NASA's Response to Comments
made in the
Aerospace Safety Advisory Panel Annual Report
on the Space Shuttle Program
dated June, 1976

Enclosure

Page 20, Para. 2.II.C.1.

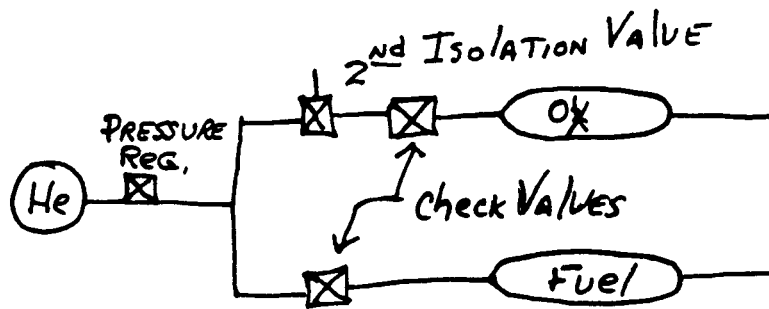
Comment: The explosion of a solid rocket booster, a main engine, the external tank, or a reaction control system in all likelihood cause the loss of an orbiter. Thus, all possible measures must be taken to prevent such an occurrence or to provide warning so that such an explosion could be prevented.

SSME Response: The Hawkins team was chartered to conduct an overall assessment of the Space Shuttle system. Out of this review came a separate "Engine Margin Review" whose objective was to "Reassess the SSME Structural Design". This assessment and structural audit was completed and reported on to the Hawkins Committee as well as to top NASA officials. Any additional reviews should start with reviewing the results of the Hawkins Team and the SSME Margin Review.

SRB Response: Plans are being implemented which identifies the approaches used, control methods, and procedures to ensure proper quality controls. These plans include identification of all failure modes, effects of these modes, hazard analysis, sneak circuit analyses and other risk assessments that could have a potential failure mode. The results of all these analyses are tracked with a continual assessment of program risks.

OMS Response: The OMS subsystem manager and design personnel met with the ASAP people at the beginning of the OMS POD development effort and adopted the following design/operational features for the OMS design to accommodate all "known" safety requirements: (a) A fire wall is designed into the pod to separate the propellant tanks from the engine proper - it is not a blast wall, however, (b) a second isolation valve was installed in the OX tanks pressurant line between the regulator and the OX tank down stream of the "Tee" junction, which also supplies GN₂ to the fuel tank.

RCS Response: (a) The RCS plumbing and tankage is designed to no-fail limits of structural stresses. (b) RCS - GSE will have vapor detection sniffer capability for personnel safety (pre and post launch). (c) RCS plumbing will be leak checked pre and post launch. (d) Filling and draining criteria same as OMS.
